ADD26623
PLAT-13511
PUD-CAD-O
APPROVED 450 SQ FT
DECK COVER

Victor Amezcua
Cover Patio

SITE PLAN

1 Site Plan
1" = 20'-0"

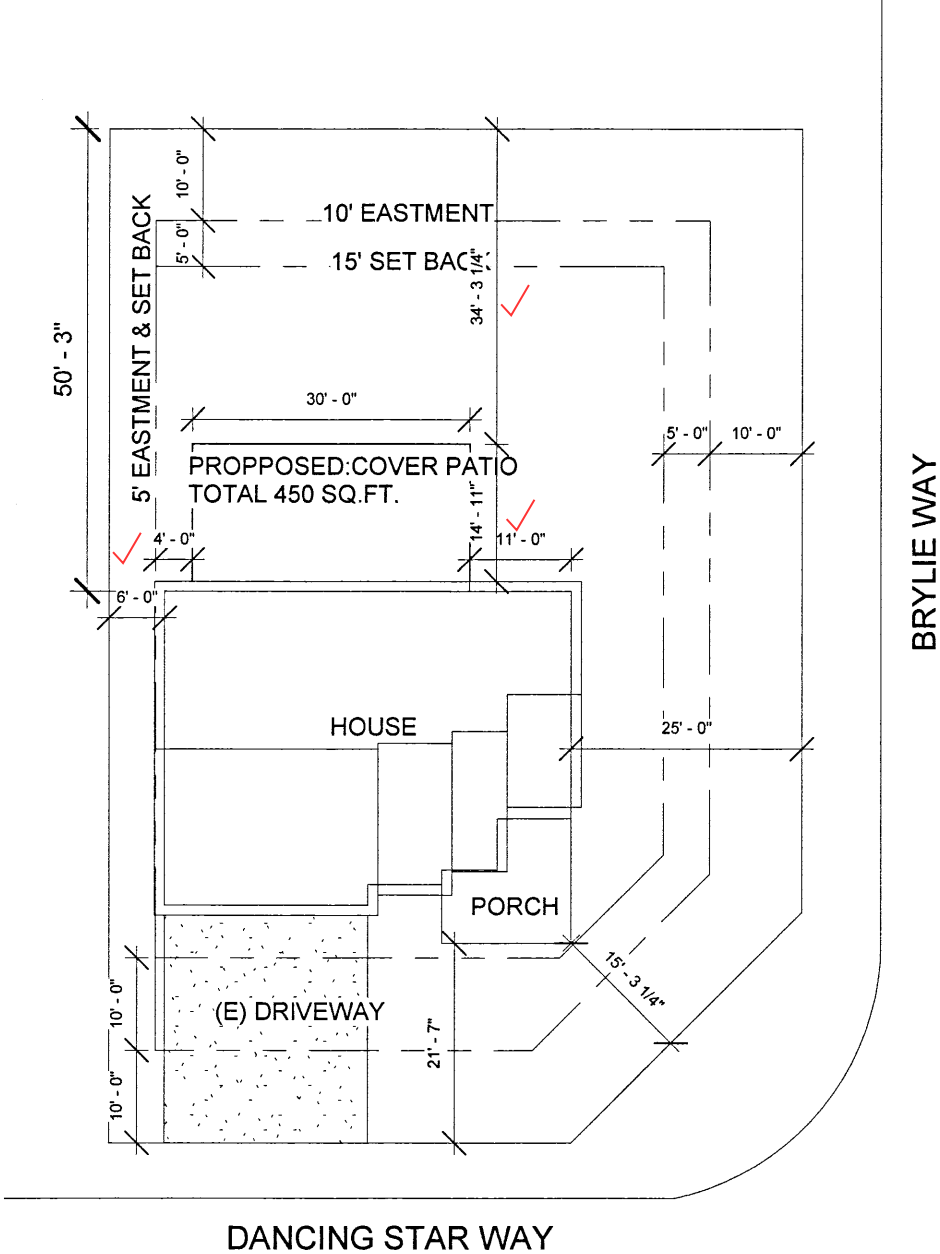
This parcel is in a low/moderate/high intensity fire risk area. Please reach out to the local fire district regarding recommendations for compliance with the WRC code.

NEW COVER PATIO
= 450 SQ.FT.
TOTAL COVERAGE AREA = ~~23.8%~~
35%
